AGENDA FOR THE CANTERBURY BANKSTOWN LOCAL PLANNING PANEL MEETING

7 August 2023 - 6.00 PM

ITEM 2	30-32 Wellington Road, Chester Hill Demolition of existing structures and construction of a four (4) storey residential flat building development comprising of 23 residential apartments, with basement and ground floor level carparking
FILE	DA 52/2022 – Bura / Bass Hill
ZONING	R4 High Density Residential
DATE OF LODGEMENT	14 February 2022
APPLICANT	Fuse Architecture Pty Ltd
OWNERS	Ace Chester Hill Pty Ltd
ESTIMATED VALUE	\$7,233,558.00
AUTHOR	Planning

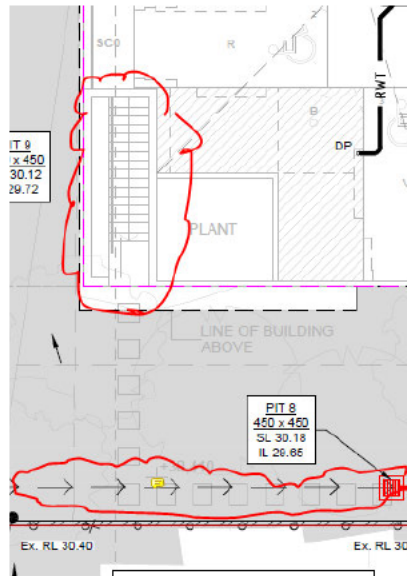
1. *Combination of convex mirror and bypassing opportunity as demonstrated on the latest architectural plan Revision B dated 7th of February 2023 is not satisfactory due to limited vision provided to an incoming driver from Wellington Road which raises safety concerns. As such, the applicant shall provide a bypassing opportunity where the sharp turn presented leading to ground floor car park to ensure no vehicle reversing backward be required (See extract below). This may be achieved by relocating the pump & plant room and providing a bypassing opportunity where the pump room currently is proposed.*

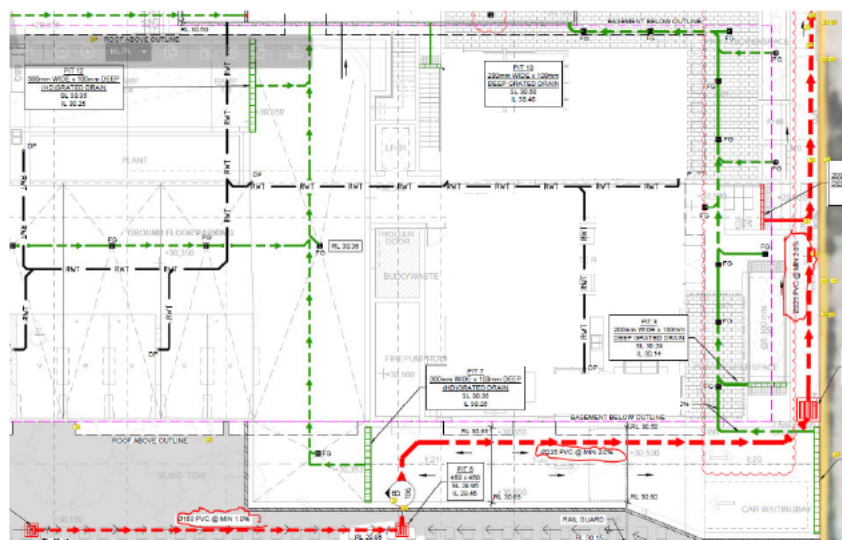
2. *The stair way leading to the basement as proposed is not supported (See extract below). Should the swale drainage system fail, the basement is susceptible to flood inundation as it is directly facing the overland flow path of the upstream catchment. The applicant shall amend the proposal to ensure the basement stairway is not facing or in proximity to the swale drainage system or overland flow path.*

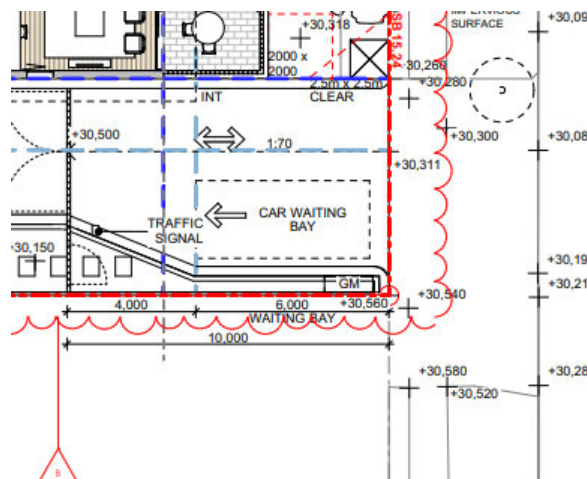
4. *The applicant shall confirm the existing kerb inlet pit located within Wellington road's invert level. All inlet and outlet's invert levels connecting to the pit shall also be confirmed on survey & stormwater management plan where extension work is proposed to enable an accurate design of longitudinal section for Council's team to further review. The current design is based on an assumed invert level of the pit which is not satisfactory. (See Extract Below).*
